**H. B. ROBINSON STEAM ELECTRIC PLANT, UNIT NO. 2**  
**DOCKET NO. 50-261 / RENEWED LICENSE NO. DPR-23**

**Subject:** Response to NRC Request For Additional Information Regarding Seismic Re-Evaluations Related to Southeastern Catalog Changes (TAC NOS. MF3724, MF3736, MF3737, MF3738, and MF3831)

Enclosure: Senior Seismic Hazard Analysis Committee (SSHAC) Level 2 Study for CEUS-SSC

**Figure 16: Seismicity with  $E[M] \geq 2.9$  occurred within 100 km of the Oconee NPP from 1968 through December 2007: a) from Rev 7 of the CEUS-SSC earthquake catalog; b) from Rev 8.**

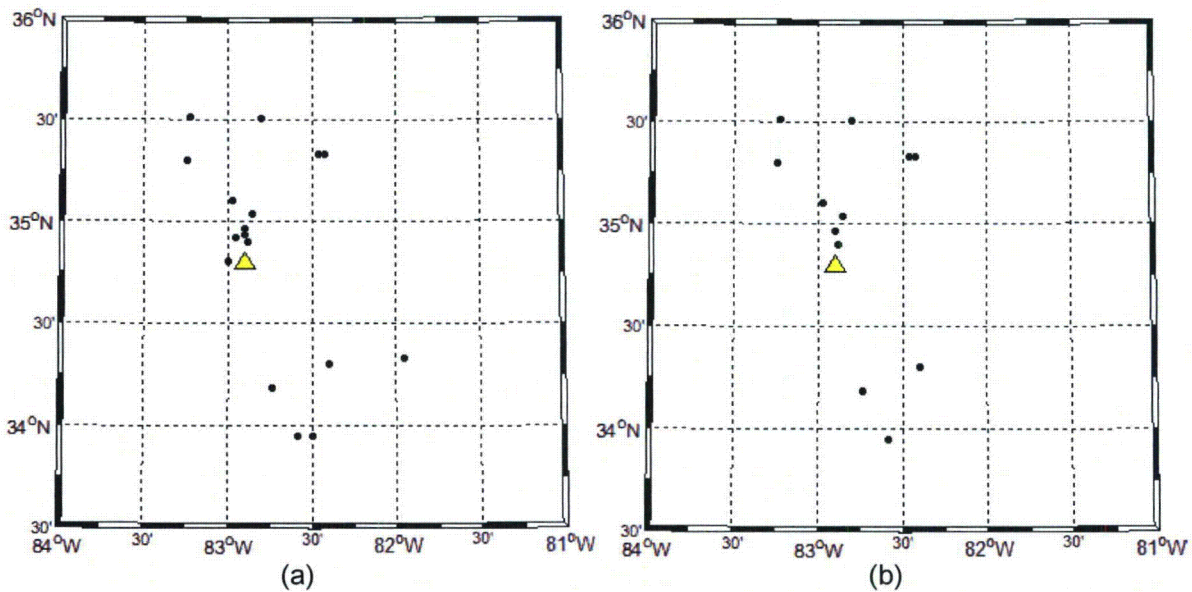
Figure 1 shows that the events in Table 4 are located in proximity of two NPPs: Oconee and VC Summer. The earthquakes located within 100 km of each NPP were plotted and analyzed to identify any other cluster of seismicity of non-tectonic origin. Figure 16 compares the earthquakes with  $E[M] \geq 2.9$  that occurred from 1968 to December 2007, located within 100 km of the Oconee NPP, from Rev 7 of the CEUS SSC Catalog (Figure 16a) and from Rev 8 (Figure

16b). The comparison indicates that the analysis presented in this report has removed several earthquakes that had previously been used to calculate recurrence rates for PSHA.

**Figure 17: Seismicity with  $E[M] \geq 2.9$  occurred within 100 km of the VC Summer NPP from 1968 through December 2007: a) from Rev 7 of the CEUS-SSC earthquake catalog; b) from Rev 8.**

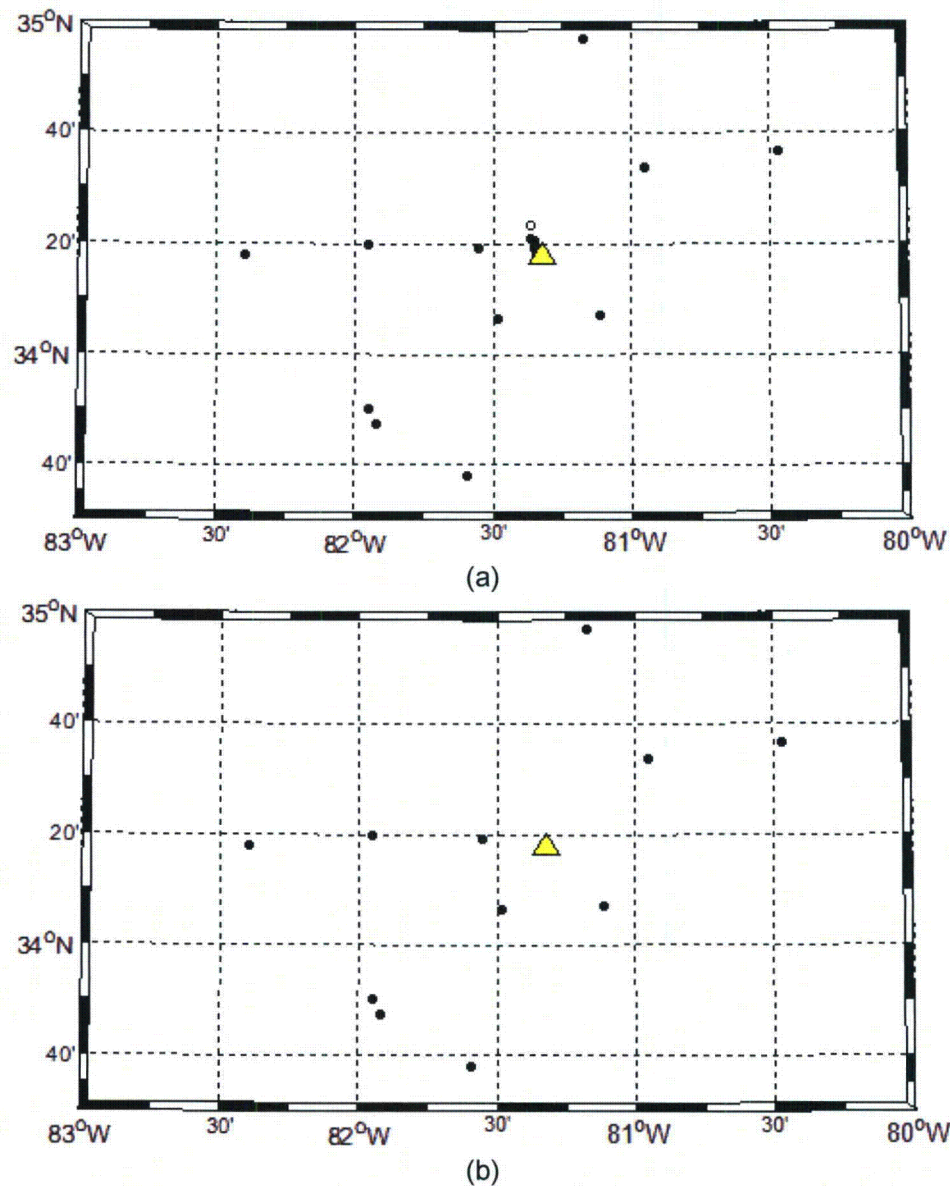
Figure 17 shows a similar comparison for the seismicity within 100 km of the VC Summer NPP: Figure 17a shows the earthquakes in Rev 7 of the catalog with  $E[M] \geq 2.9$  occurred from 1968 to December 2007; Figure 17b shows the earthquakes from Rev 8 of the catalog. The cluster of earthquakes associated with the Monticello Reservoir has been effectively removed from the earthquake catalog in Rev 8.

**Figure 18: Isoseismal map for January 19, 1860 earthquake provided by Donald Stevenson and Dr. Predeep Talwani (written communication, February 19, 2014).**

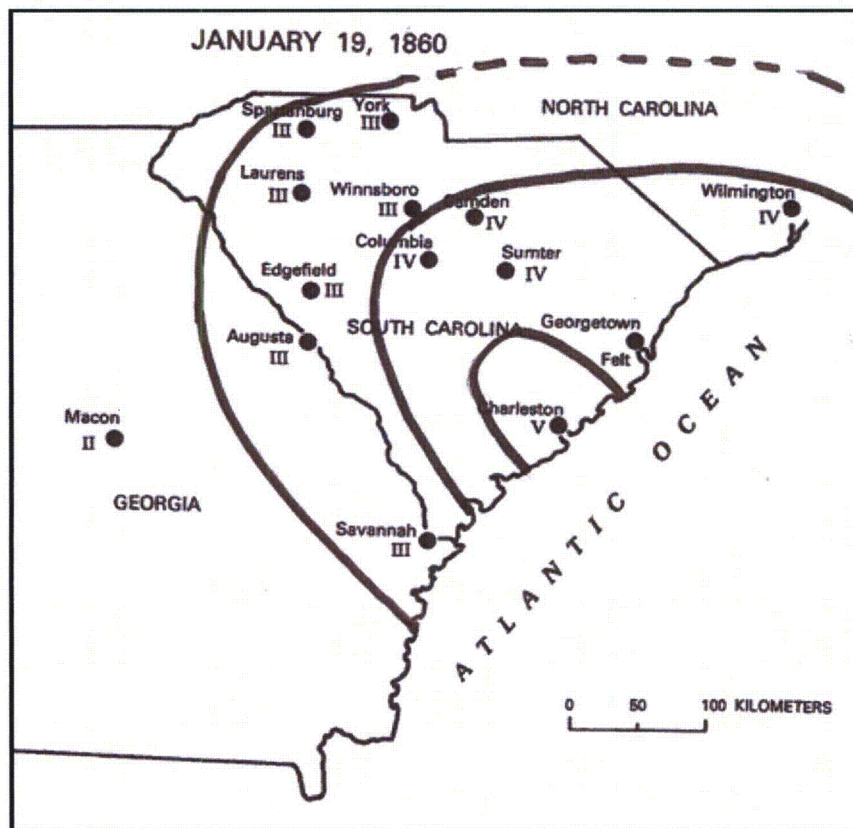
The location in the Rev 7 catalog is based on NCEER-91. Donald Stevenson and Dr. Predeep Talwani provided the isoseismal map shown below based on their interpretation of the available intensity data. This interpretation suggests a location near Charleston. The recommendation is to utilize the Charleston location given in the SUSN catalog.

**Figure 20: Comparison of In(FA)-I0 data for Category 4 Earthquakes from Seeber and Ambruster (1987) with data from other earthquakes from the CEUS SSC Rev 7 catalog.**

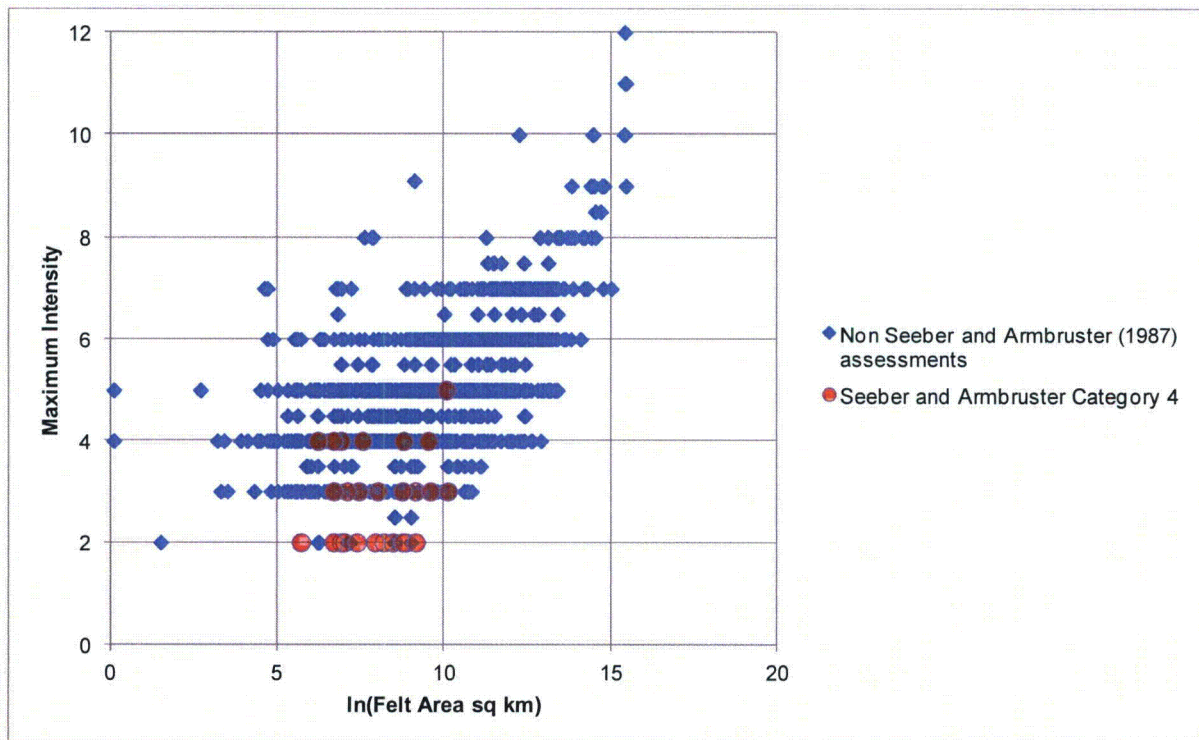
The comparisons for the Category 4 earthquakes on Figure 20 show general consistency in the  $I_0$ - $\ln(\text{FA})$  data with the rest of the catalog. Many of the Category 4 earthquakes have locations near Charleston. These events are left in the catalog.

Although this event was listed as a category 4 earthquake in Seeber and Armbruster (1987), it was not carried forward into NCEER-91. Also the  $\ln(FA)$  of 8.46 is anomalous compared to the  $I_0$  of II (Figure 20). The recommendation is to not use the felt area reported by Seeber and Armbruster (1987), which will result in the event not being considered in estimation of earthquake recurrence.

Although this event was listed as a category 4 earthquake in Seeber and Armbruster (1987), it was not carried forward into NCEER-91. Also the  $\ln(FA)$  of 8.92 is anomalous compared to the  $I_0$  of II (Figure 20). The recommendation is to not use the felt area reported by Seeber and Armbruster (1987), which will result in the event not being considered in estimation of earthquake recurrence.

**Figure 21: Comparison of  $\ln(\text{FA})-I_0$  data for Category 5 Earthquakes from Seeber and Armbruster (1987) with data from other earthquakes from the CEUS SSC Rev 7 catalog.**

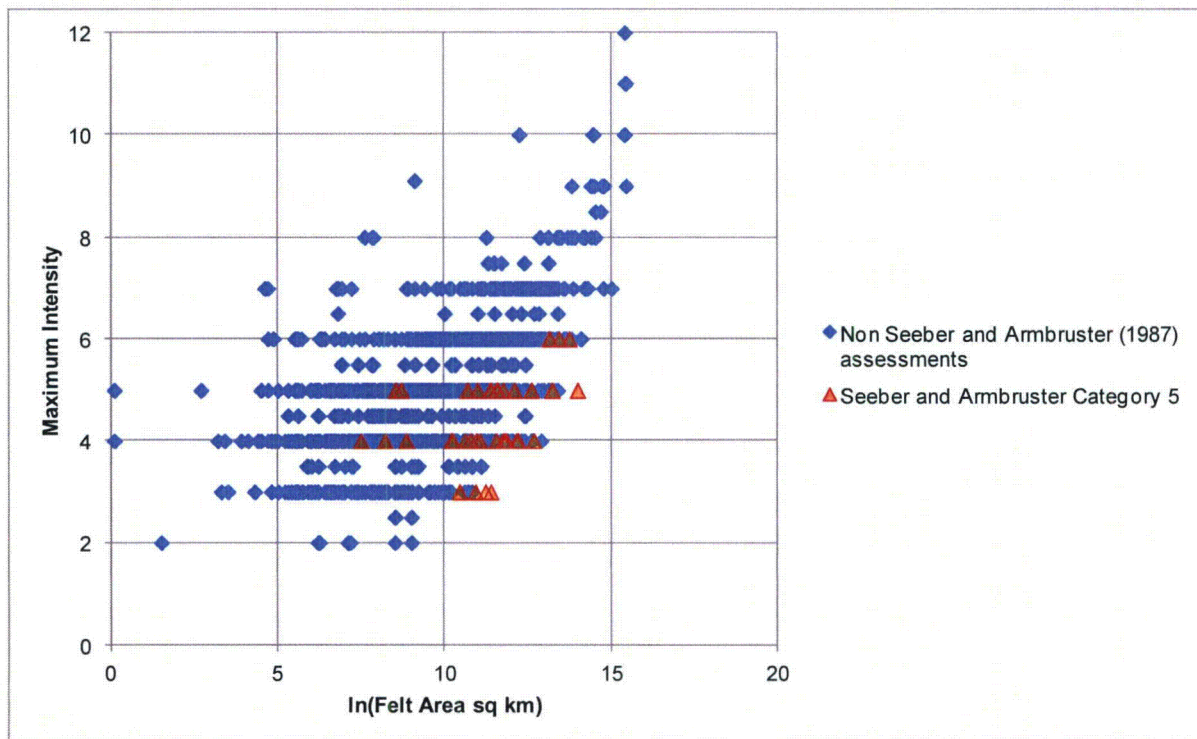
The remaining question is the large number (about 25) of the Category 5 earthquakes. A number of these have SUSN entries with the same time, but often significantly different locations. Category 5 is considered by Seeber and Armbruster (1987) as the best located. Five of the interpreted mislocated earthquakes discussed in Part 2 are Category 5 earthquakes, indicating that there are issues with some of these locations. In addition, the data shown on Figure 21 indicate that the assigned  $\ln(\text{FA})$  may be biased high for this category. These events were examined again in comparison to other events in the catalog from SUSN.

This is a Category 5 earthquake in Seeber and Armbruster (1987) and is listed in NCEER-91. Its  $I_0$  (IV) and  $\ln(FA)$  (8.22) are consistent with the general population of CEUS SSC earthquakes (see Figure 21). Stevenson and Talwani (written communication, Feb 26, 2014) indicate:

▲ Figure 1. Intensity data for the earthquake on October 22, 1886 at 10:20 UTC. The assigned radii for intensities IV and V are shown by dashed arcs.

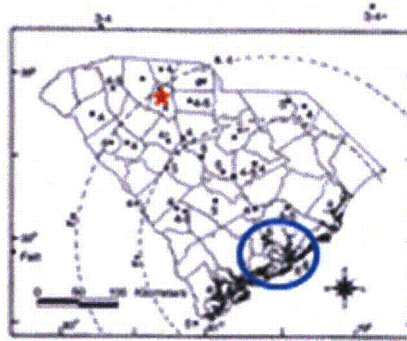
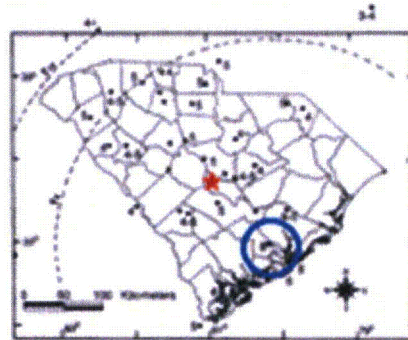
4. **TMP02019 and 02025:** These are two aftershocks of the Charleston earthquake. They were felt over a wide area. The macroseismal data were evaluated by Talwani and Sharma (1999), who located it in the Summerville area and revised the magnitude estimates.. Isoseimal data for these earthquakes and the revised locations by Talwani and Sharma are shown on the maps below taken from that paper, and compared with the WRONG locations (red stars) listed in the existing catalog.
